REMOVE DRILLING FLUIDS AND CARRY OUT AN EXTENDED WELL TEST. THIS PROPOSAL IS A TWO-STAGE ACTIVITY:

LOWER STUMBLE EXPLORATION SITE, OFF LONDON ROAD, BALCOMBE, RH17 6JH

With regards the Environment Agency's (EA) consultation response dated 11th November 2019 (Ref: HA/2019/121694/01-L01), please see below and attached, which seeks to address each of the issues raised:

Hydrogeological Risk Assessment

Scale: 1:500
Size: A2
Sheet: 1 of 1
DWG. No:
ZG-AE-BAL-EWT-HDPE-01

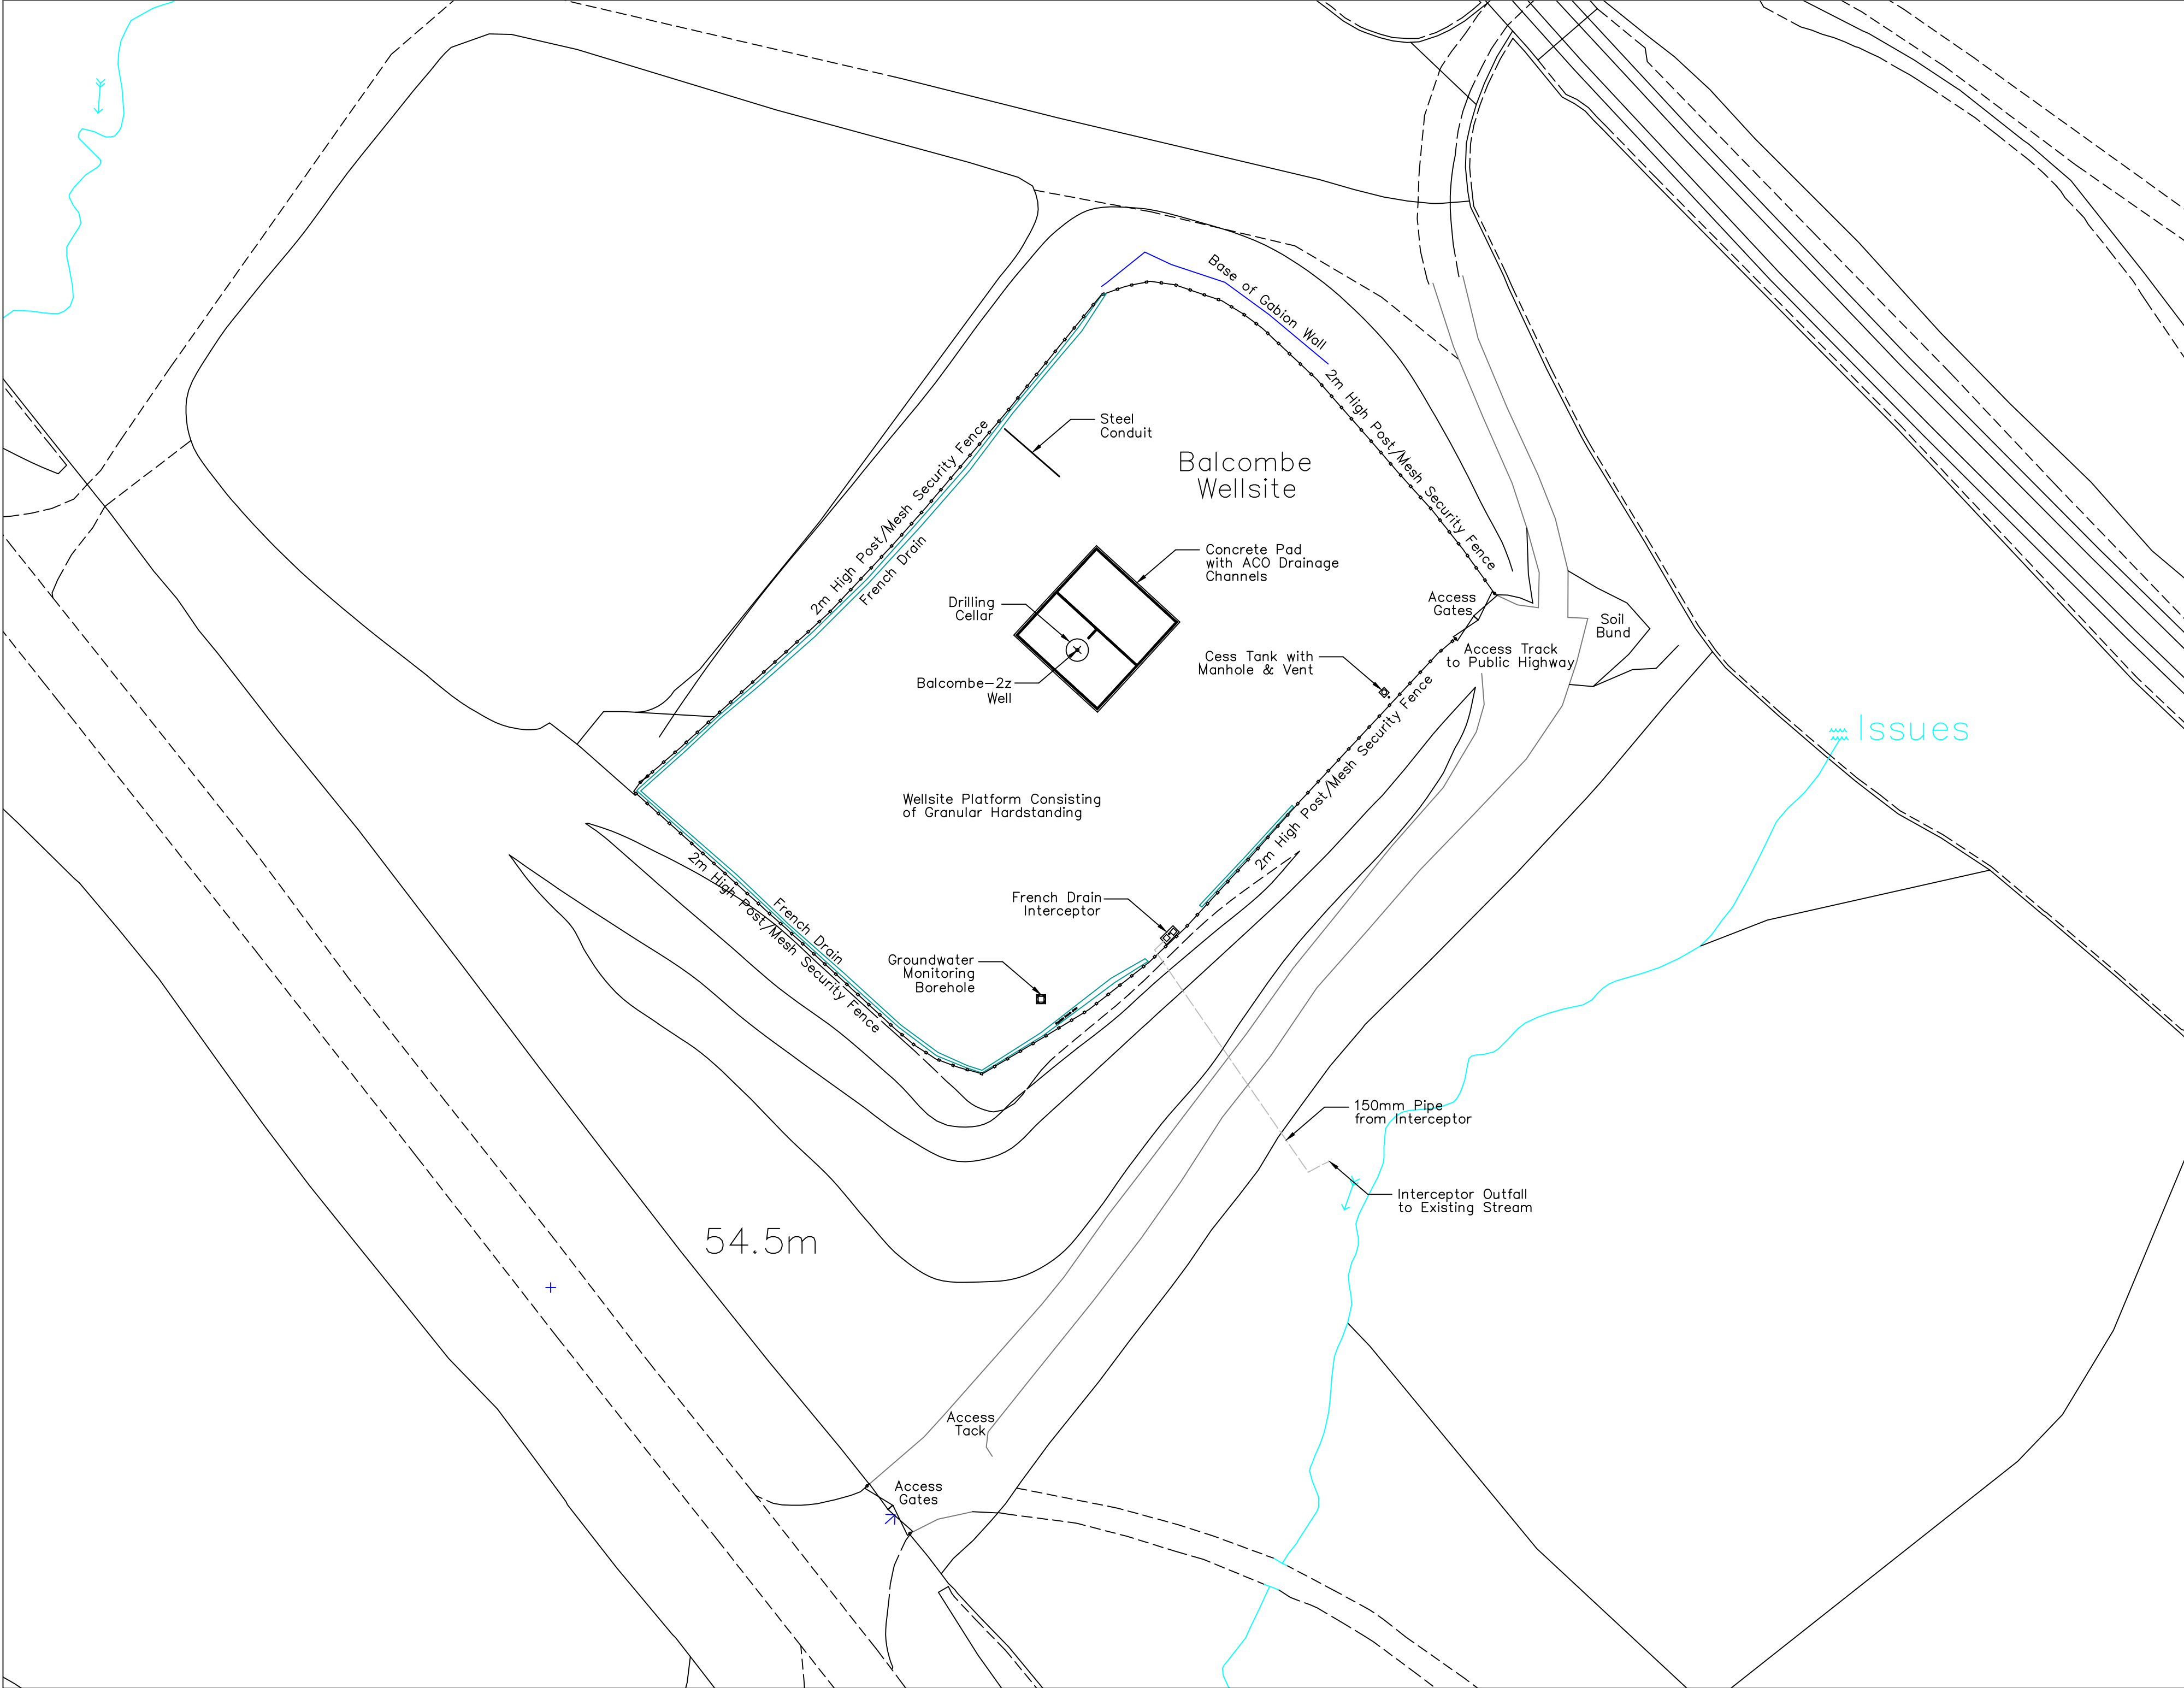
While we could be in a position to accept proposed system for short term pollution control, we would need to be satisfied of the durability of this system for longer term activities. We would not regard more than 1 year of testing as a short term activity. We would need to be satisfied that the system outlined in section 8.5 of the Planning Statement is not sufficiently robust for the proposed duration of the pump testing.

The design and construction of the Subbase is outlined in the detailed engineering drawings within the Design Philosophy Statement (**Appendix 2**). This fully engineered system will be more than robust enough for the requested duration of the EWT, incorporating adequate protection of the HDPE membrane from truck movements in and out of the site.

PROJECT: DESIGN PHILOSOPHY FOR
FULLY ENGINEERED
IMPERMEABLE SUBBASE

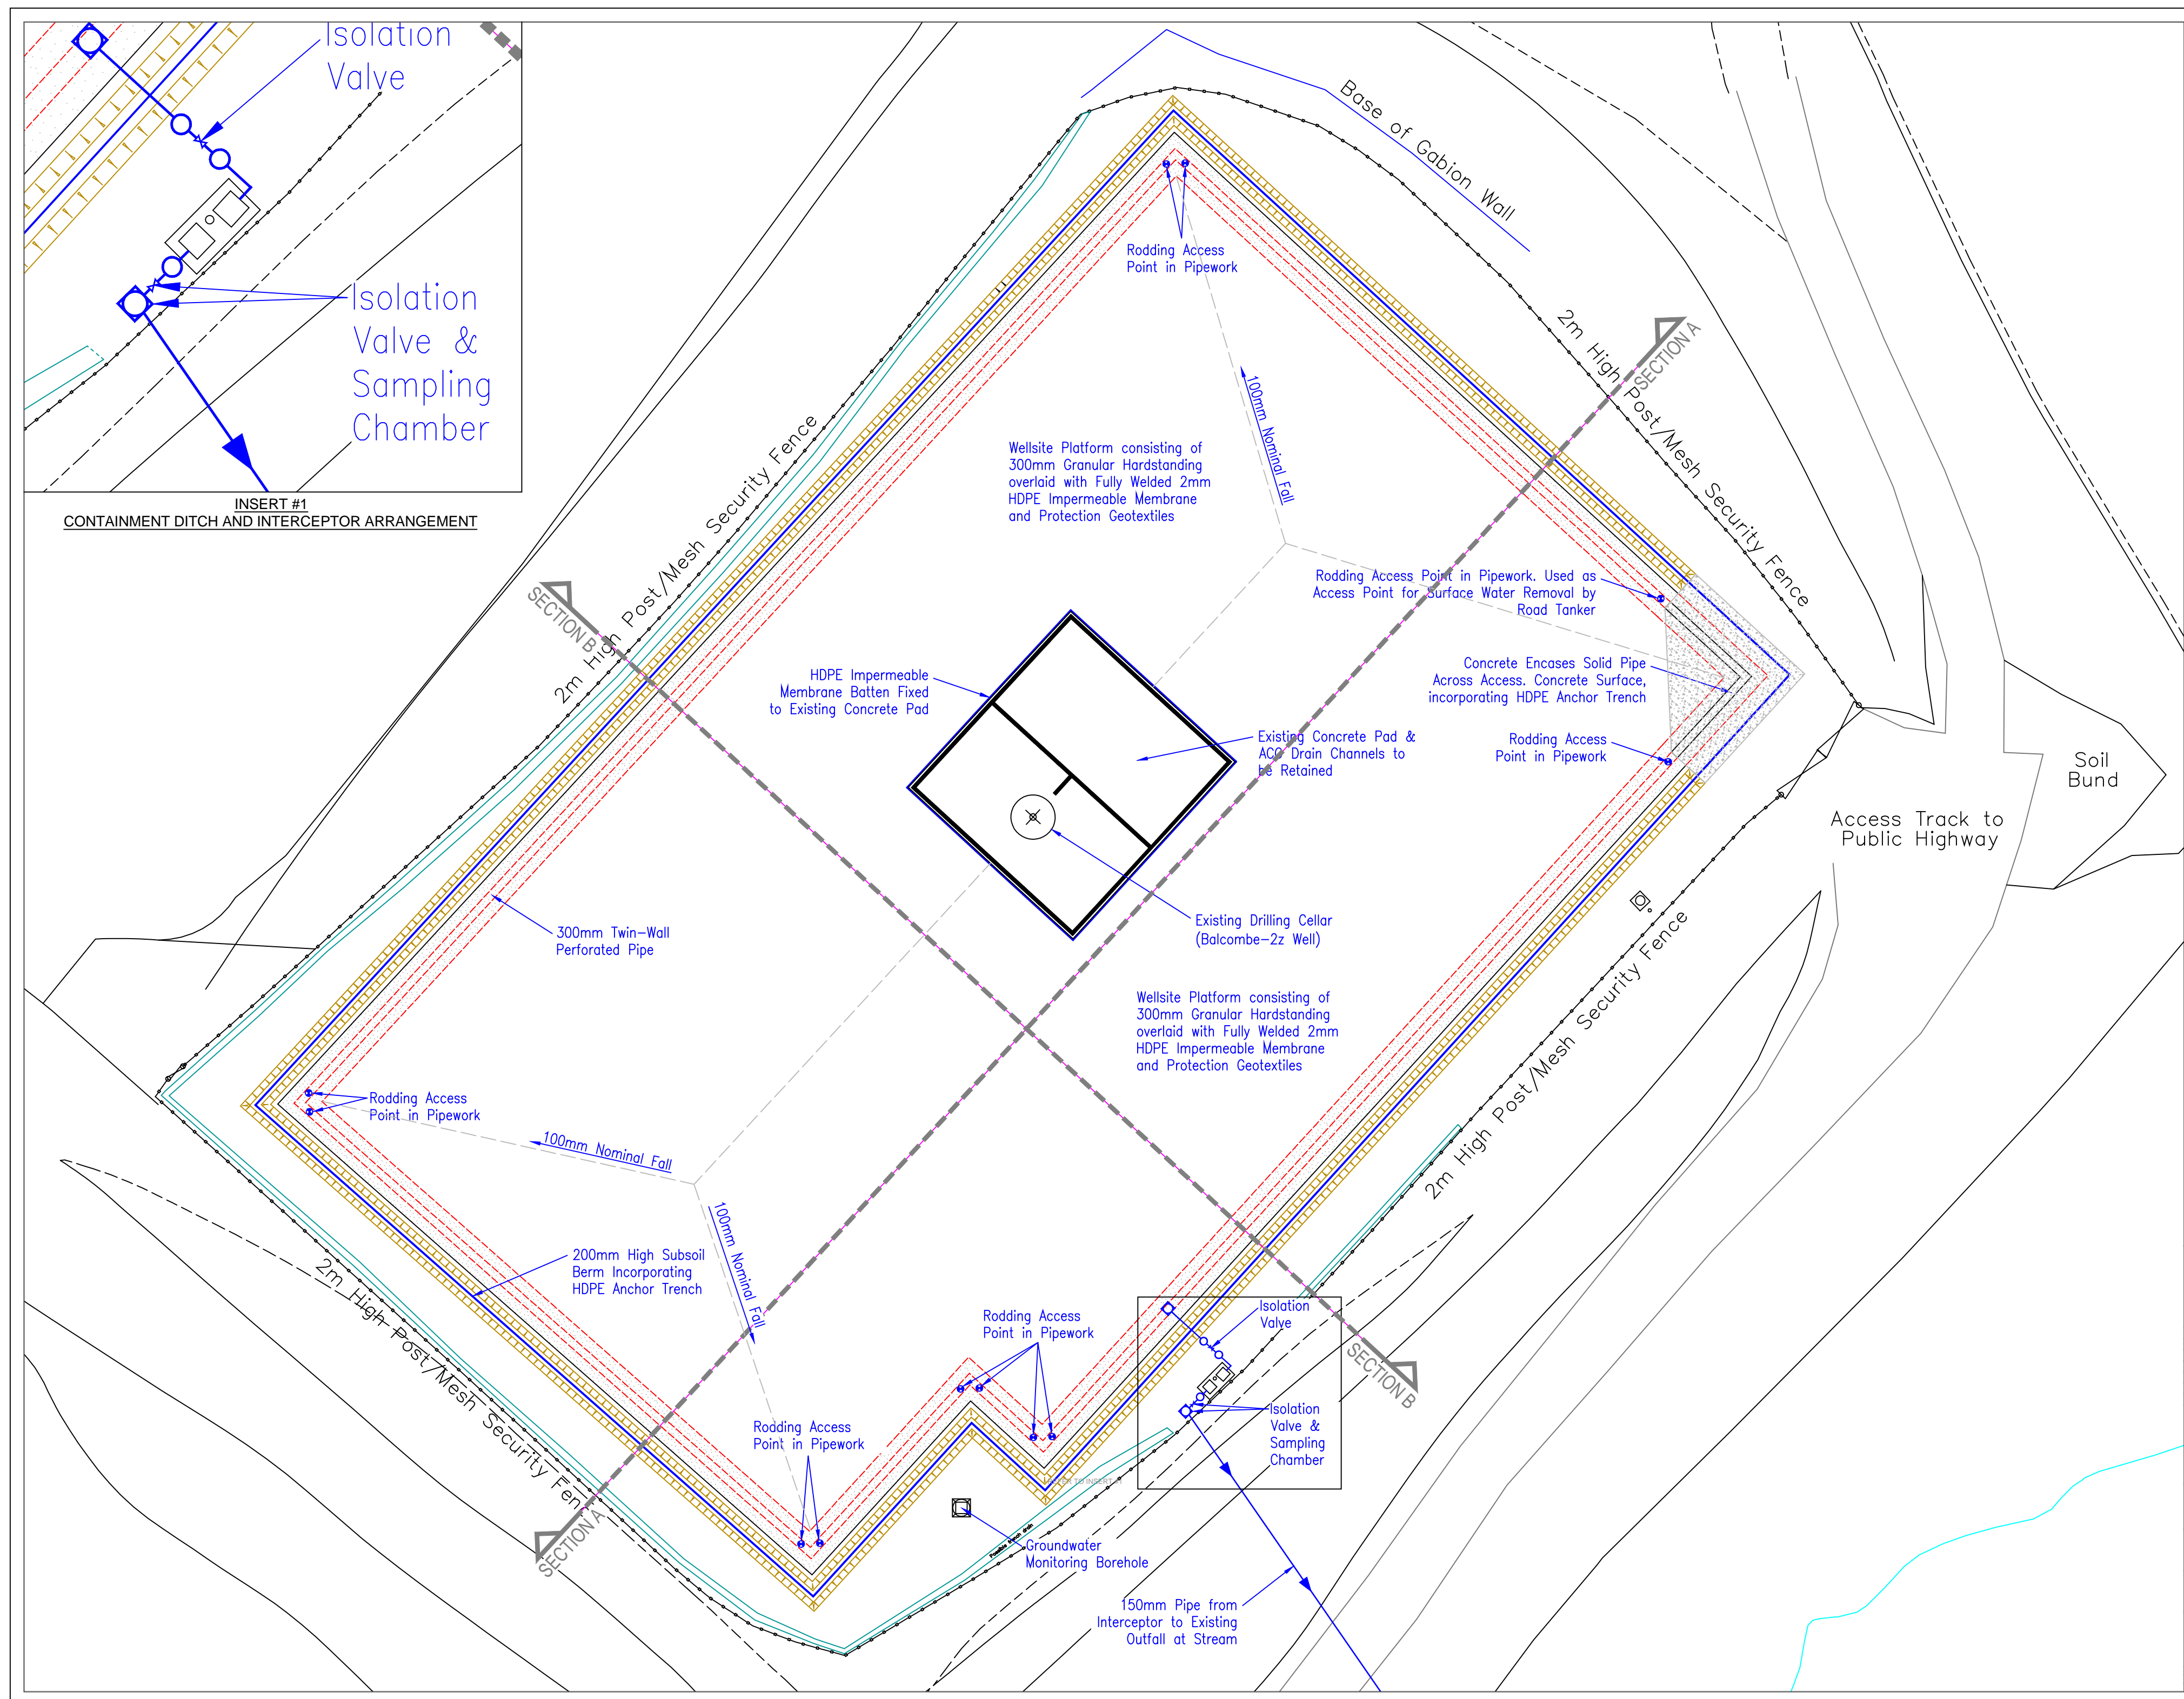
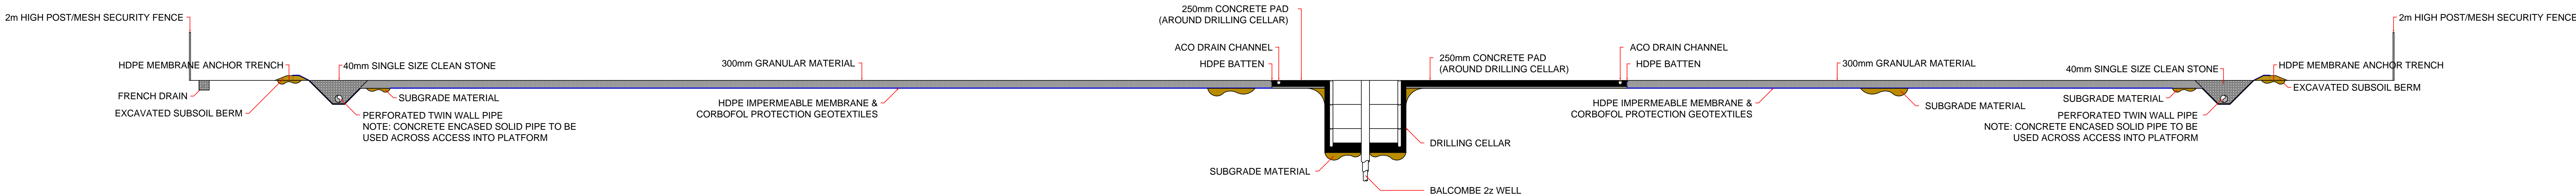
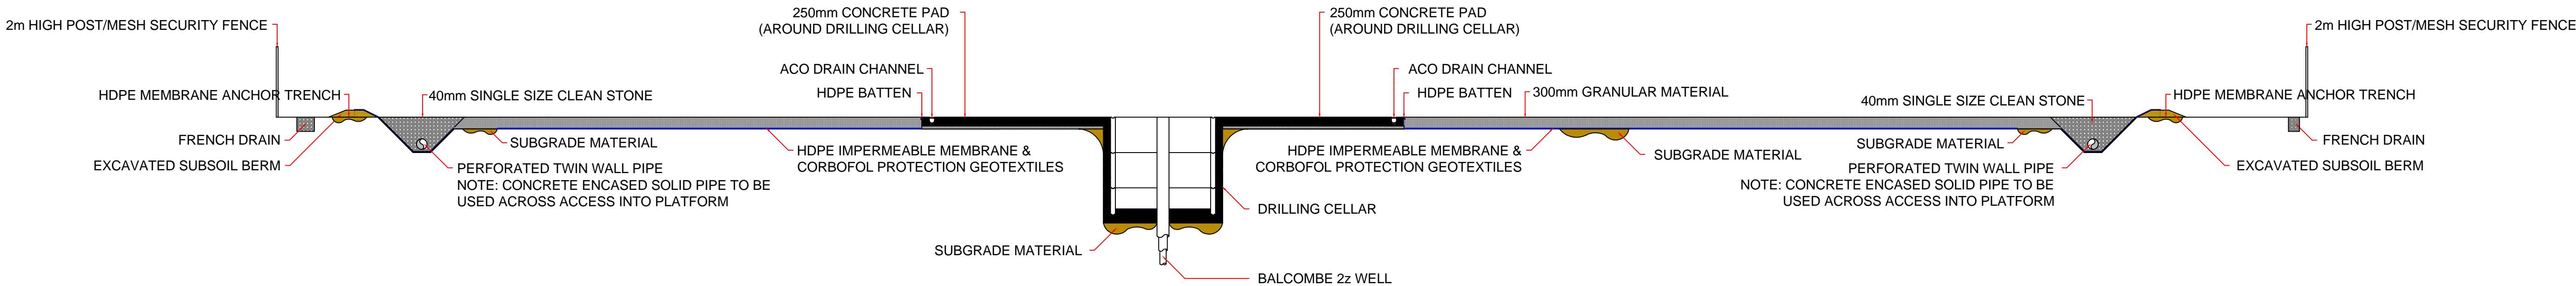
- Calculations for the bund size in section 8.5.1 are just for the initial stage 1 water lift. They do not reflect the site in Phase 2 extended well test. The calculations also do not account for structures within the bund. We would require calculations which account for all significant structures within the bund area for both the phase 1 water lift and the extended well test as well.
- We also note that no bund is specifically identified in the key on the submitted plan for the extended well test. For clarity this should be added.

As mentioned, the table in section 8.5.1 of the planning statement and the associated bund dimensions are for stage 1. The stage 2 Impermeable Subbase is outlined in the Design Philosophy Statement, and the more complete set of equipment for stage 2 is detailed in section 8.4 and in Appendix 1 of the planning application, however, is reproduced below for clarity of significant structures that will be present in stage 2:
